Information note

N° 042/21

Optimization of snap-in design for Easy 3B

<u>Old</u>	<u>New</u>
Old snap-in design	New snap-in design

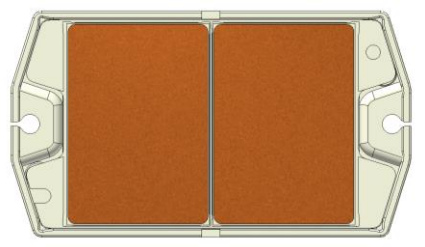
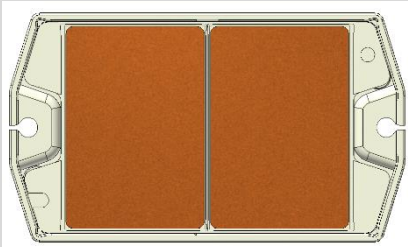
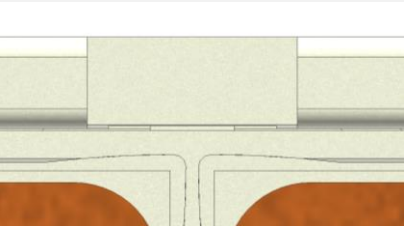
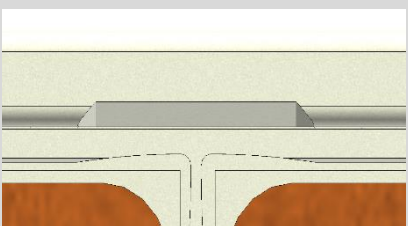
Subject Optimization of snap-in design for Easy 3B for better handling in the production line.

Reason Continuous improvement.

No impact on fit, form or function of the products.
- ▶ **Attachments**
